Transit Stop Accessibility

Contract Number: T-15-019-201 Chattanooga Department of Transportation

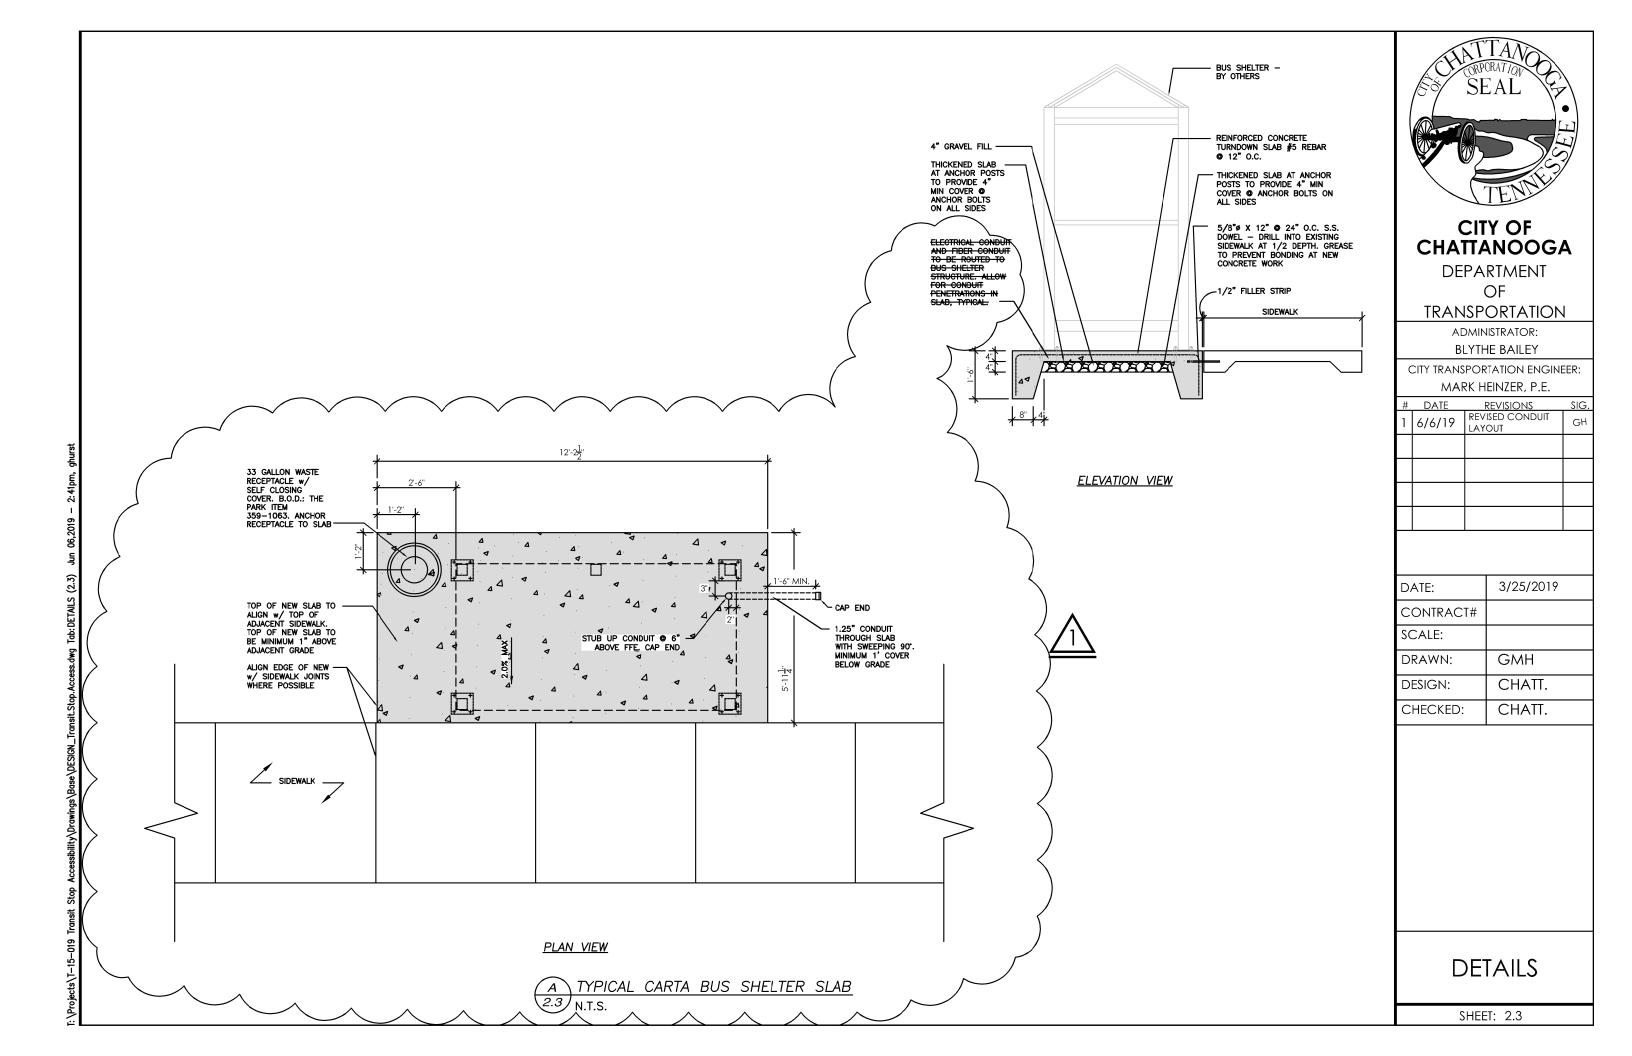
- **Question 2:** On sheet 2.3 reference is made to "electrical conduit and fiber conduit to be routed to bus shelter structure. Allow for conduit penetrations in slab, typical" will the sleeves or conduits for these penetrations be supplied by others for installation into the slab and will the sweeps to outside the plan footprint of the slab be required by the contractor? If required, to what distance past the edge of the shelter slab? If the conduit is not provided, what dimensions will the penetrations need to be for these penetrations?

- **Response 2:** Sheet 2.3 has been revised (see **attached**). Conduit shall be supplied by the contractor.
- **Question 3:** In the pre-bid meeting it was indicated that the desired schedule for the project would be included we have been unable to locate any schedule information relative to overall project duration. Will a project schedule be published or should the contractor just submit the proposed schedule with our proposals?

Bus Shelter Anchor Detail for Brasco Monumental Series MN408.

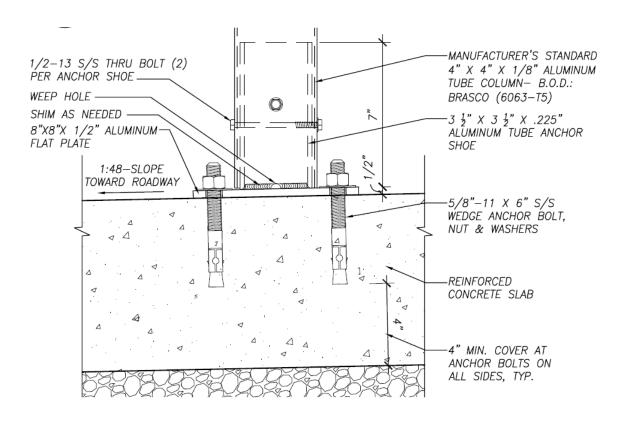
- **Question 1:** On sheet 2.3 reference is made to "Bus Shelters by others" will the anchor bolts for these units be provided by others or does the contractor need to provide? If we need to provide please supply the requirements for the anchor bolts.

- **Response 1:** For clarification; The bus shelter is "[manufactured] by others" but shall be installed by the contractor, and any required assembly shall be completed by the contractor (per Bid Schedule line item 'MISC-A'). The shelter manufacturer shall provide exact mounting specifications and also information on the included hardware. **Attached** is an anchor bolt detail for a Brasco, Monumental Series MN408 as an example. (Line item 'MISC-A' specifies Brasco, Monumental Series MN408 or **approved equal**).
